TRUCK, CARGO, LIGHT, MC2, ALL TYPES FITTED WITH WINCH
LAND ROVER 110 6X6

REWORK OF THE WINCH REAR DRIVESHAFT

MODIFICATION INSTRUCTION

FIG 1 - WINCH REAR DRIVESHAFT REWORK

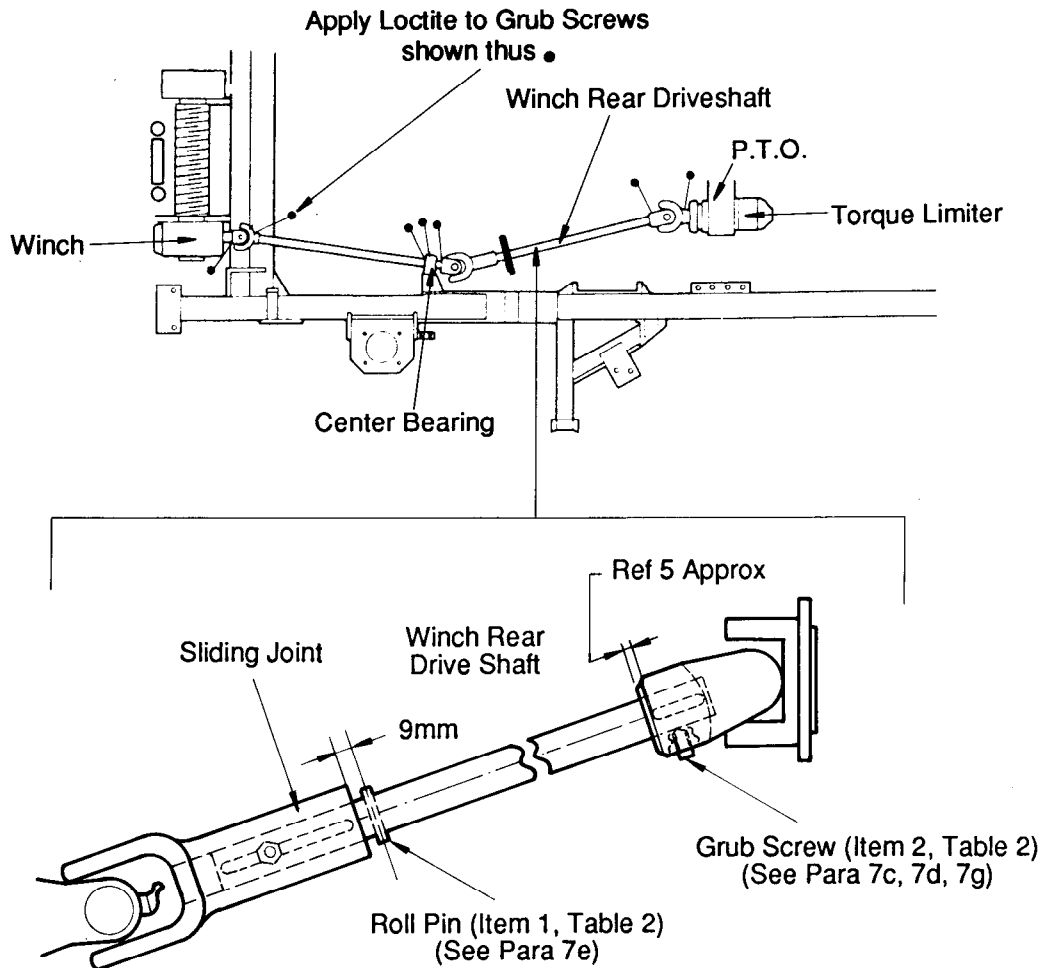
1. This instruction details the rework of the winch rear driveshaft due to problems with shaft dislodgement on early vehicles. The reworked driveshaft has a roll pin fitted adjacent to the slip joint to limit shaft travel, an improved grub screw fitted to aid shaft retention and Loctite 262 applied to the threads of all other winch driveline grub screws.

7. The modification is to be carried out as follows, with reference to Fig 1 for component location:

- a. Locate the sliding joint on the winch rear driveshaft and mark the shaft 8 - 9 mm from the sliding joint.
- b. Remove the winch rear driveshaft, ensuring that the driveshaft is indented at the position of the existing rear grub screw.
- c. If the grub screw position is not clearly identifiable, refit the driveshaft and carefully drill through the threaded grub screw hole on the PTO flange to mark the shaft.
- d. Using a 6 mm drill bit, spot drill the driveshaft at the rear grub screw mounting point to a depth of 3 mm.
- e. Locate the previous mark on the sliding joint end of the driveshaft and using a 6 mm drill bit drill through the shaft and fit the roll pin (item 1 from Table 2).

- f. Refit the driveshaft to the flange and sliding joint.
- g. Fit and tighten the new grub screw (item 2 from Table 2) to the rear driveshaft flange after applying Loctite 262 (item 2 from Table 1) to the screw threads, ensuring the point of the grub screw indents into the shaft.
- h. Remove all other winch driveline grub screws, apply Loctite 262 to the threads, refit and tighten the screws.
- i. Test the operation of the winch.
